**THE PROPOSED ROTHER VALLEY RAILWAY  
(BODIAM TO ROBERTSBRIDGE JUNCTION) ORDER**

**REBUTTAL PROOF**

**FLOOD RISK**

**Figure 2-2: Typical section through the floodplain downstream of the bifurcation, east of the A21**

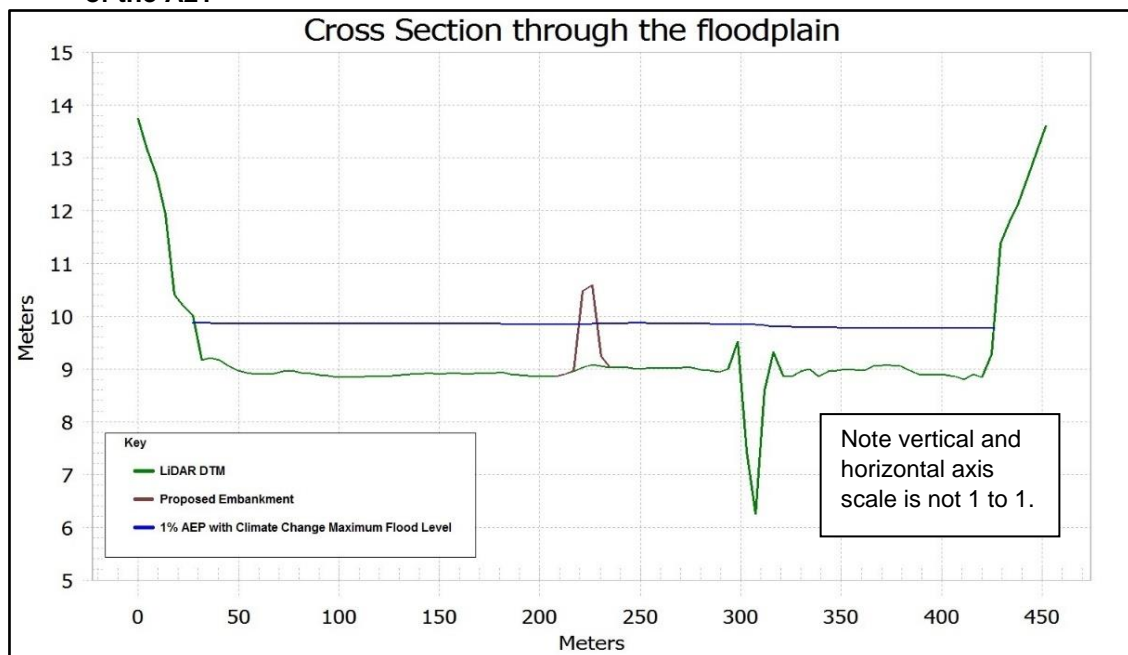
2.10.2 The proposed embankment passes through the middle of the floodplain. The floodplain is wide and relatively flat as shown by the typical cross section shown below in Figure 2-2, taken from the LiDAR DTM downstream of the A21.

2.10.3 If required, floodplain storage compensation would need to be provided at the extremities of the floodplain and not immediately adjacent to the proposed embankment. A number of potential locations at the edge of the floodplain have been identified but ultimately this is a matter for compliance with planning conditions requiring analysis of requirements and approval of proposals by the Environment Agency.
